CITY OF SAN ANTONIO

Re: Oliver Ranch POADP # 662

The City Staff Development Review Committee has reviewed Oliver Ranch Subdivision Preliminary Overall Area Development Plan # 662. Please find enclosed a signed copy for your files. Although your plan was accepted, please note the following:

PUD/POADP PLAN

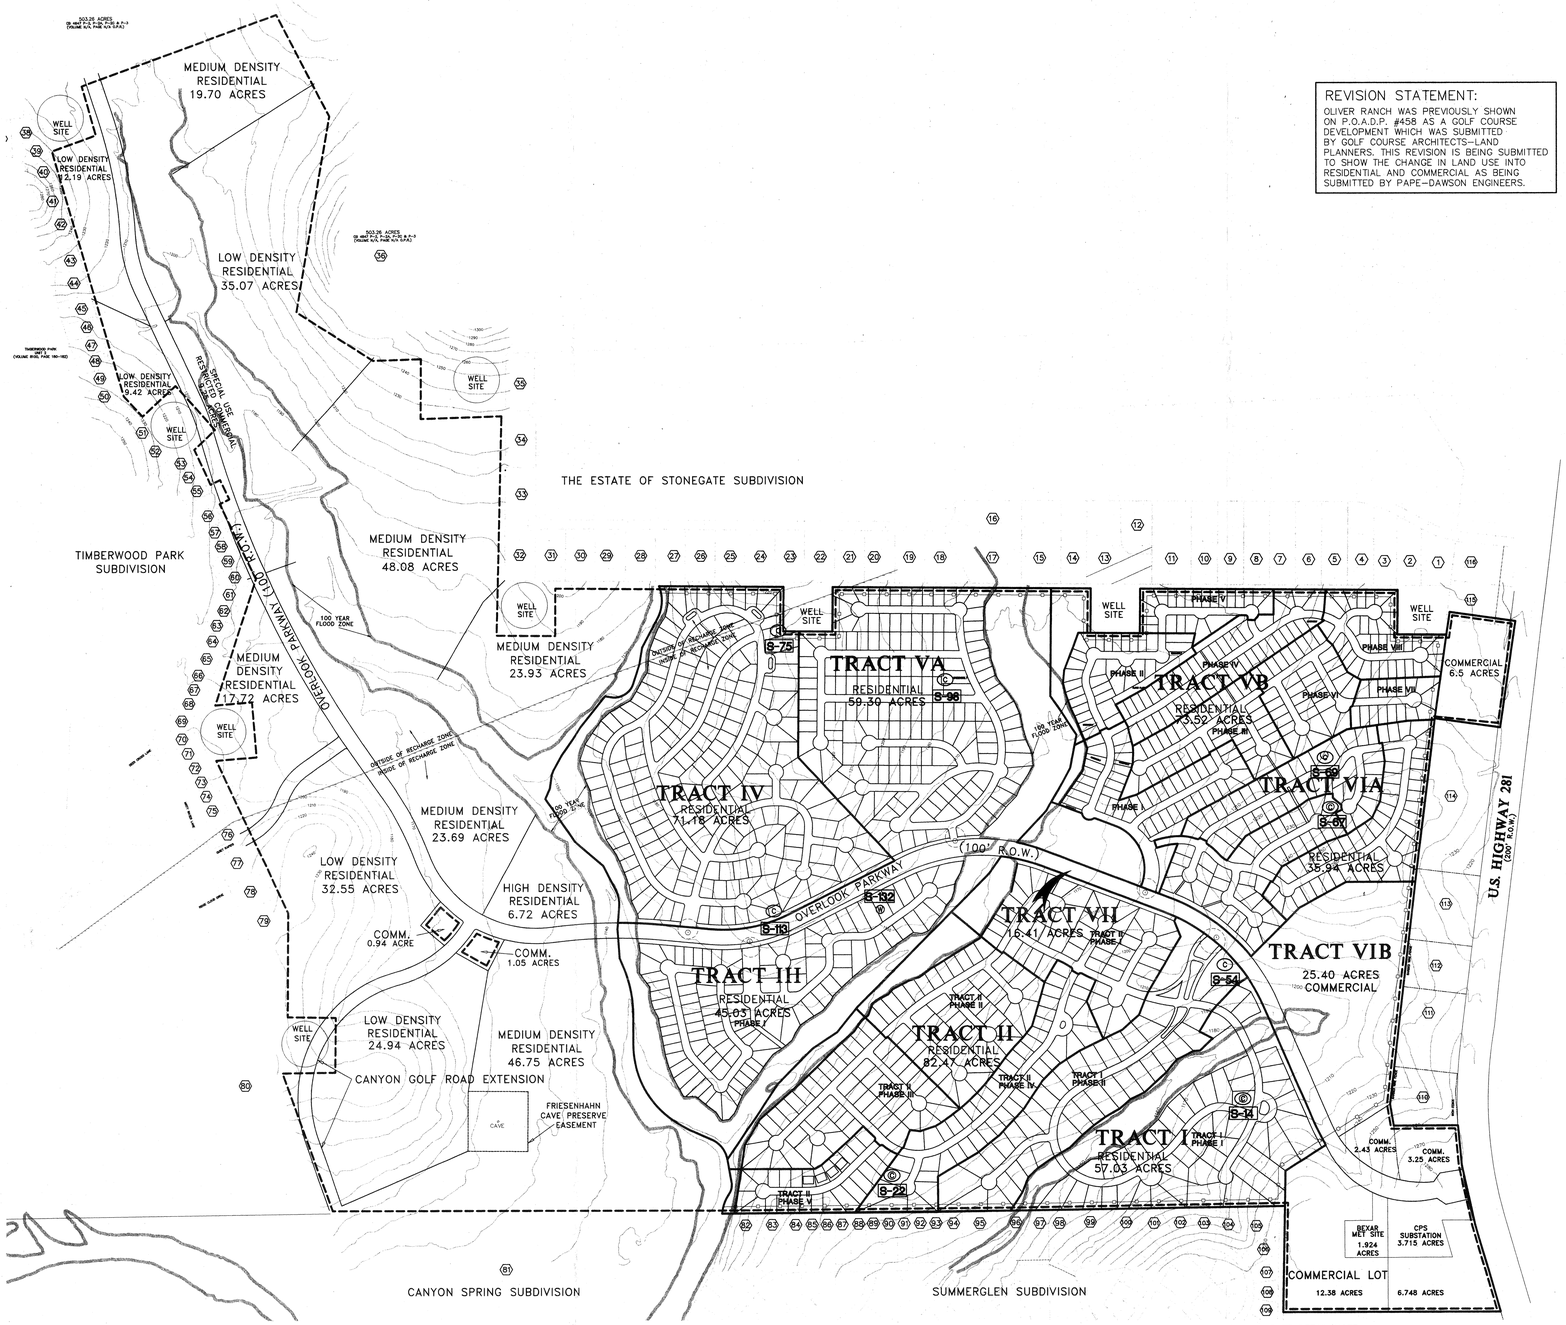
- Based on the topography, a Flood Plain Study and drainage review will probably be required during the platting process. Bexar Co. Public Works will require base flood elevations at the plat level.

- In consideration of public safety and convenience, excessive grades by reason of topography should be avoided in street layouts and arrangements.

- This development will probably need to conform to requirements associated with development over the Edwards Aquifer. For additional information about these requirements you can contact SAWS at 704-7305.

- Access and R.O.W. issues along State facilities will need to be resolved with the Texas Department of Transportation (TXDOT). For information about these requirements you can contact TXDOT at 615-5814.

- This development will need to comply with tree preservation ordinance #85262. For information about these requirements you can contact Building Inspections at 207-7102.

- It will be expected that you will plat all of the property depicted in your POADP, to include: floodpains, drainage areas and open space.

- I would encourage you to work closely with the school district, so that they can plan accordingly.

- It should be understood that the submitted TIA is a conceptual plan and therefore this document does not represent an approval for the internal street plan. Reduced number of driveways and common access between the commercial lots are encouraged in order to provide safe and efficient movement of traffic to and from, within and past, the proposed development, while minimizing the impact to non-site trips. For information about these requirements you can contact Building Inspections at 207-7587.
